**PUBLIC HEARING: RESOLUTION OF NECESSITY TO ACQUIRE  
ASSESSOR'S PARCEL NUMBER 053-0141-021  
FOR THE SOUTH SACRAMENTO CORRIDOR PHASE 2  
LIGHT RAIL EXTENSION PROJECT**

**STAFF PRESENTATION**

**January 11, 2010**

LAYOUT PLANS  
FIGURE 2.4-5

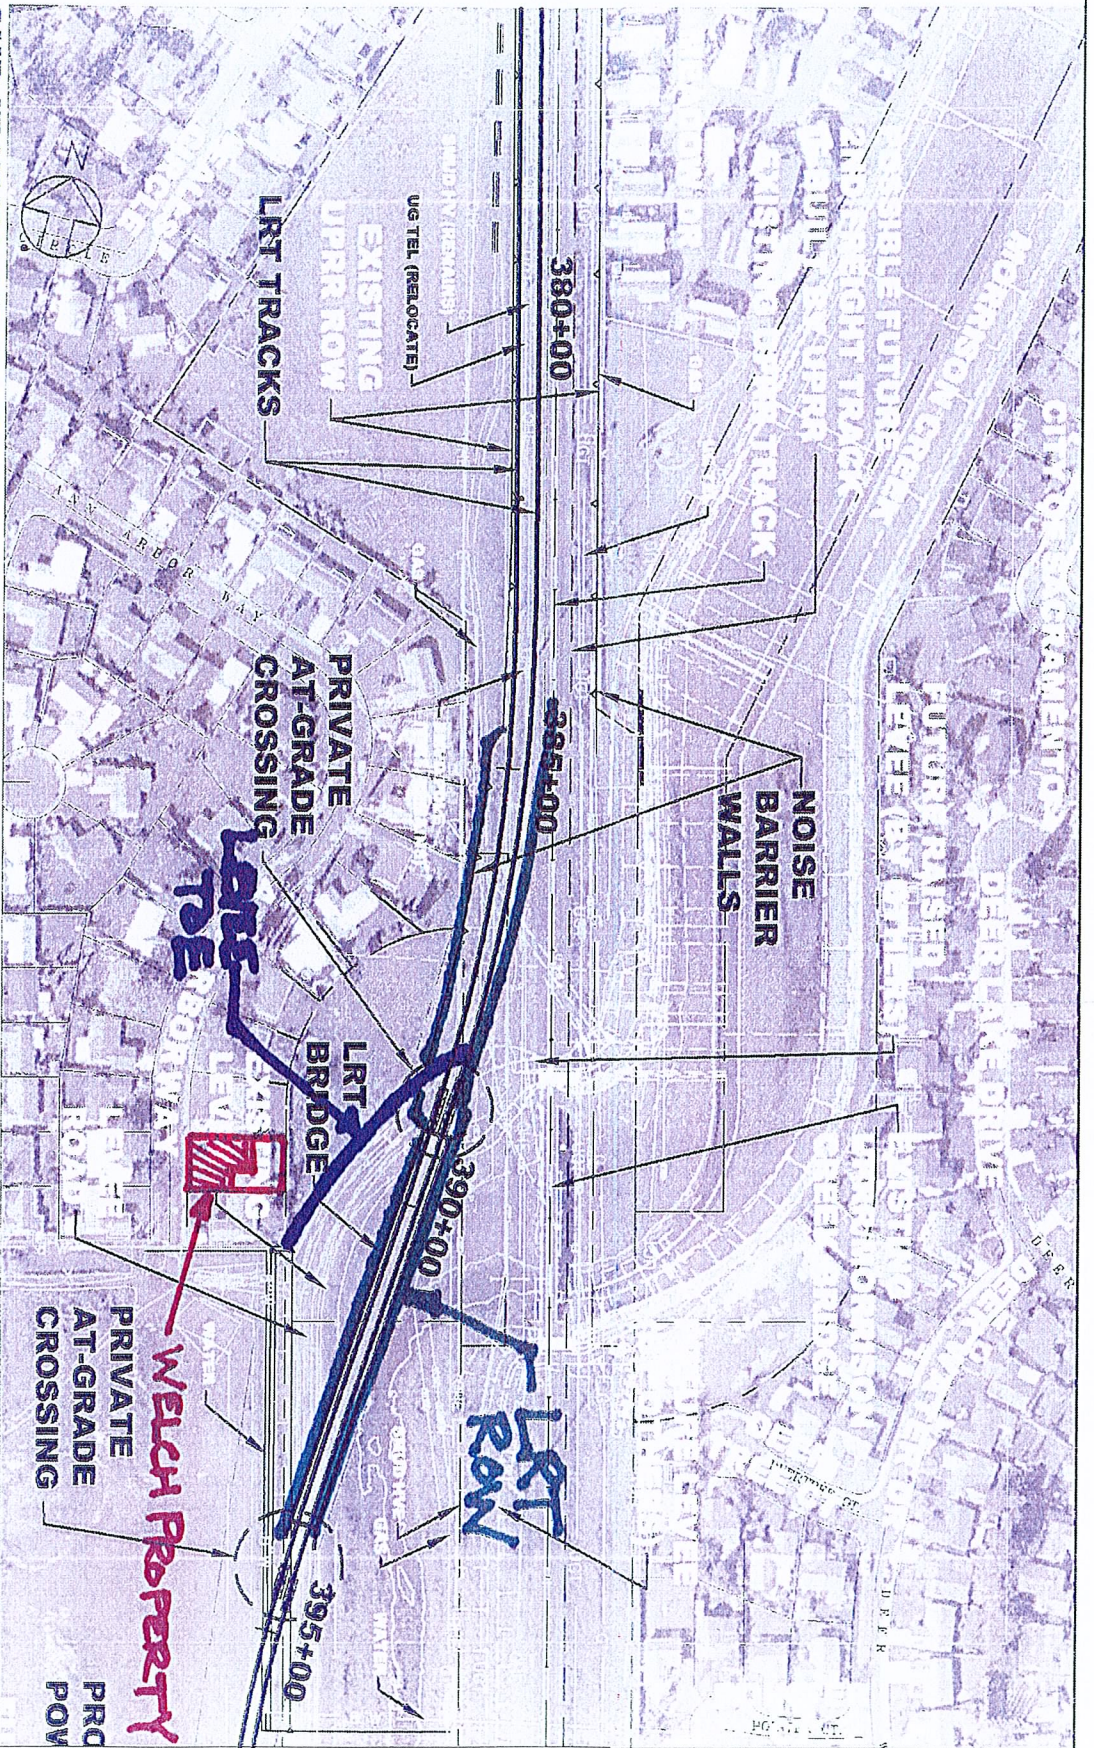
City Utilities (Mike and Stu) - Stated that they do not like the currently proposed LRT alignment and bridge that cuts across the westerly levee in two places and across the corner of Morrison Creek. It was stated that these LRT facilities prevent City Utilities access to the stop log gate across the UPRR track. Also they do not want to see piers located in the levees. This statement also applies to the UPRR Flyover bridge. They would prefer for the alignment to be moved to the west of the levee which would require acquisition of adjacent residential properties.

RT (Diane, Dave and Dave) – Stated access to the stop log gate has been maintained with the new facilities. The top of levee road goes around the bridge abutments and crosses over the tracks at private road crossings.. Also the existing road ramp at the corner of the levee stays in place and is not affected by the LRT project.

COE FUTURE LEVEE SECTION (ALTERNATIVE 2)

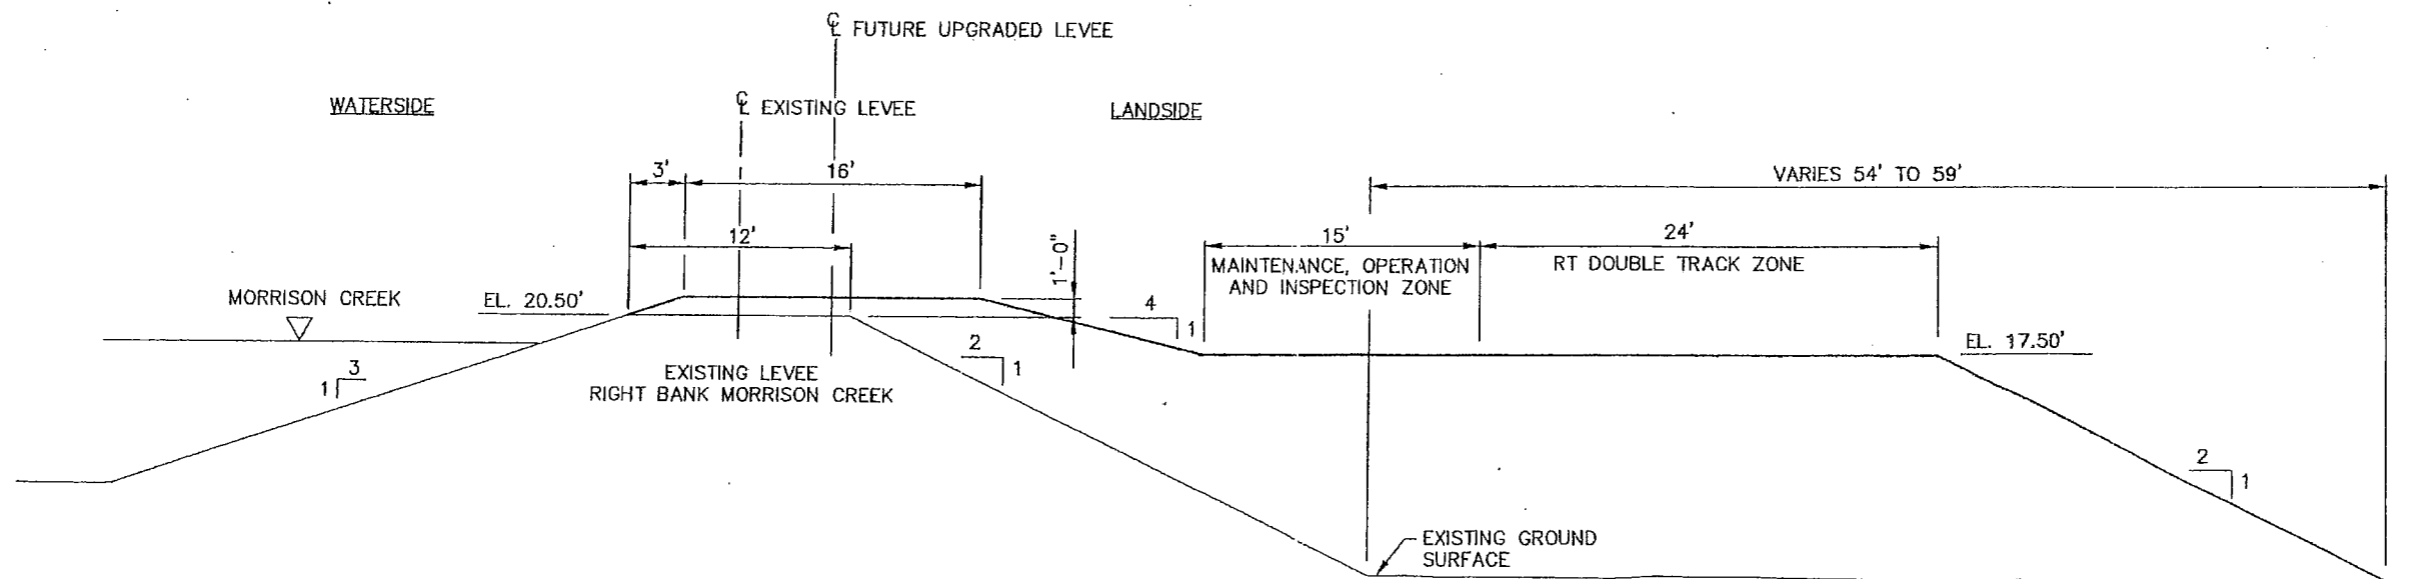
- SAFCA says that the LRT alignment/embankment may now need to accommodate a future 4:1 landside slope with a 15' toe road. This governs over previous 50' clearance requirement from existing levee toe provided by City Utilities. Grant Kreinberg handed out a couple of very conceptual typical sections (see attached) to illustrate the possible requirements.

- Per Rec Board any embankment constructed up against a levee will be considered as part of the levee and therefore an inspection road is required at its toe. Therefore a 15' inspection road is required to the outside of the "Super Levee" section even though the Super Levee may be much wider than a levee with a 4:1 slope.

LAYOUT PLANS  
FIGURE 2.4.5

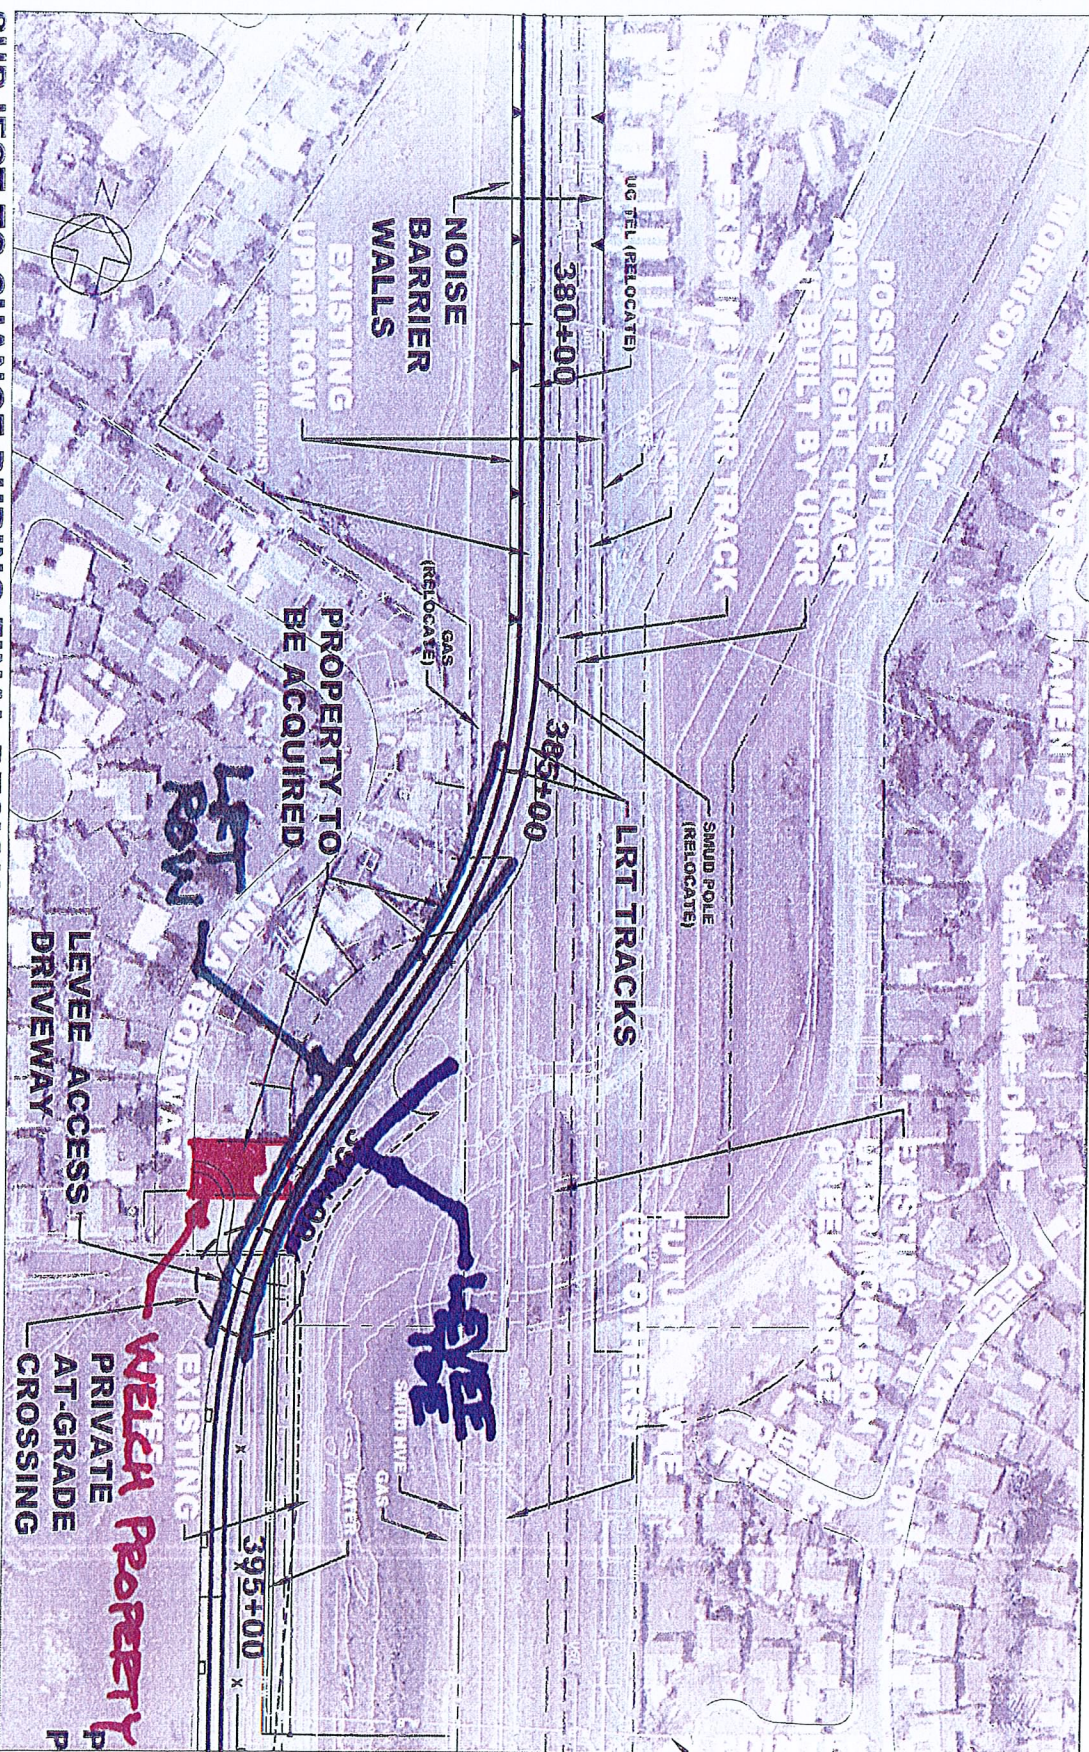
Where RT power lines cross the levee or access route to the levee (e.g., access from Ann Arbor Way to Morrison Creek west levee near UPRR bridge), raise power lines to provide minimum vertical clearance of 18 feet, plus any additional clearance required in vicinity of power lines.

Provide access for flood control maintenance equipment to enter Morrison Creek from right bank / west levee downstream of UPRR bridge. Provide minimum vertical clearance of 18 feet, plus any additional clearance required for safety in vicinity of RT power lines.

For RT at-grade crossings of levee crown, in addition to provisions for private road crossing, provide alarm & warning system for RT trains approaching crossings.

Bridge / bridge piers shall not restrict access for maintenance vehicles to Morrison Creek. Bridge piers & bents shall be designed so as not to restrict low flows or flood flows, or cause erosion. RT shall be responsible for repairing any erosion to flood control facilities in vicinity of the bridge piers & bents. Consider paving waterside levee sideslope at bridge abutments and along entire bridge length because of restricted access for levee maintenance equipment.

*This proposed RT bridge will restrict flood control operation, maintenance, inspection and flood fight activities. Consult with California Reclamation Board for criteria for running RT tracks on and/or even "diagonally across" the levee at-grade. The Utility Department, which is responsible for this section of levee maintenance, strongly recommends realigning the new RT tracks so that they will be entirely off (west) of the Morrison Creek levee and out of Morrison Creek.*

The LRT alignment has been revised so that it does not now cross the levee. The existing levee access road will cross the LRT alignment and an 18 foot minimum vertical clearance will be provided.

RT has revised the LRT alignment based on comments received from the Department of Utilities, City of Sacramento. As shown on Figure 2.4-5 SFEIS/SFEIR, Volume I, the revised alignment does not impact access into the creek. Therefore no new access into the creek is proposed. A new access road has been provided for flood control maintenance equipment access from Ann Arbor Way. The access road will provide access to the top of existing levee at the current location. Where this road crosses the LRT 18 foot minimum clearance will be provided.

The LRT alignment has been revised so that it does not cross the levee road. The levee access road from Ann Arbor Way will continue to cross the LRT alignment. Given the light and sporadic usage of the access road and the fact that it will not be a public crossing, crossing protection per California Public Utilities Commission Standard No. 1-C (stop sign with Private Railroad Crossing sign) is proposed. Use of active warning devices does not appear to be warranted and if used would present an adverse noise impact to the adjacent residences from the warning bells.

RT has conferred with the Department of Utilities of the City of Sacramento and has revised the LRT alignment at this location so that it will be west of the current levee with no bridge over Morrison Creek or tracks crossing the levee. Rather, the tracks will run west of the existing levee on a "super levee" – a widened levee – to the west of where the bridge had been proposed at the corner of the creek. Once south of this super levee section, the alignment swings out further to the west off the levee right of way. Refer to Figure 2.4-5, Volume I of the SFEIS/SFEIR.
